Access Compliance Report Public Rights-of-Way (Curb Ramps)

Main Street: SIERRA_ALTA_DR Cross Street: RED_HILL_AVE Location: SW

ADA ID: RPRK211014174058 Ramp Type: Type 7 - Directional 2 Initial Pass/Fail: Fail Overall Compliance: No Severity Score: 2

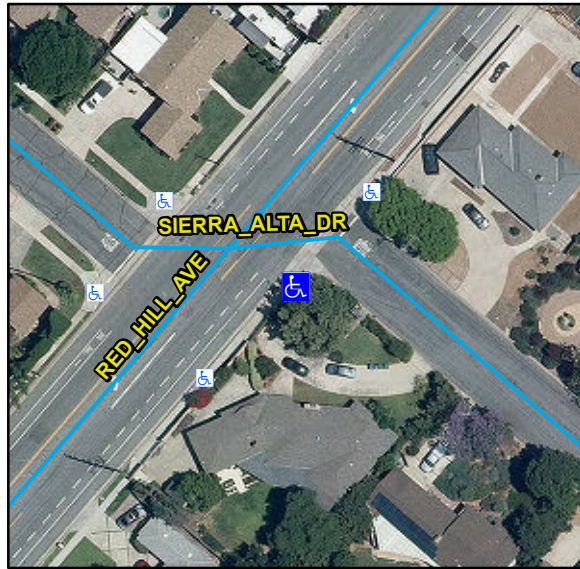
Compliance	Description	Data	Compliance	Description	Data
N/A	Ramp Length (in)	152	N/A	Flare Type LT	
Yes	Ramp Width (in)	48			N/A
Yes	Ramp Run Slope (%)	6.2	N/A	Flare Slope LT (%)	N/A
No	Ramp Cross Slope (%)	2.3	N/A	Flare Traversable LT	N/A
N/A	Grade Break	N/A	N/A	Flare Type RT	
N/A	Grade Break Slope (%)	N/A			N/A
N/A	Grade Break Cross Slope (%)	N/A	N/A	Flare Slope RT (%)	N/A
	Addl Para Ramp Left?	No	N/A	Flare Traversable RT	N/A
	Addl Para Ramp Right?	No	N/A	DWS Provided	N/A
N/A	Landing Present	N/A	N/A	DWS Contrast	N/A
N/A	Landing Length (in)	N/A	N/A	DWS Length (in)	N/A
N/A	Landing Width (in)	N/A	N/A	DWS Full Width	N/A
N/A	Landing Run Slope (%)	N/A		DWS Offset Type	N/A
N/A	Landing Cross Slope (%)	N/A	N/A	DWS Left Offset (in)	N/A
N/A	Landing Movement Obstructed?	N/A	N/A	DWS Right Offset (in)	N/A
	Landing Movement Type	N/A			
N/A	Landing Shared	N/A			
N/A	Marked Crosswalk 1	No	N/A	Clear Space	N/A
	Crossing 1 Direction	NE	N/A	Clear Space To Crosswalk (in)	N/A

Marked Crosswalk 1 Width (in)	N/A			
N/A	Ramp Inside Crosswalk 1	N/A			
	Crossing 1 Slope (%)	4.1			
	Crossing 1 Cross Slope (%)	1			
N/A	Gutter Ponding	N/A	N/A	Curb Slope	34
No	Gutter Lip Height (in)	1		Road Run Slope (%)	N/A
N/A	Gutter Run Slope (%)	N/A		Road Cross Slope (%)	N/A
N/A	Gutter Cross Slope (%)	N/A		Parallel Ramp Side	Left
Yes	Overall Surface Condition	Acceptable	Yes	Perp Joint Present	Yes
	Cross Gutter Present?	Yes		Spandrel Present?	Yes
	Replace Cross Gutter?	No		Replace Spandrel?	No

Remove & Replace Entire Ramp. Grind Gutter Lip.
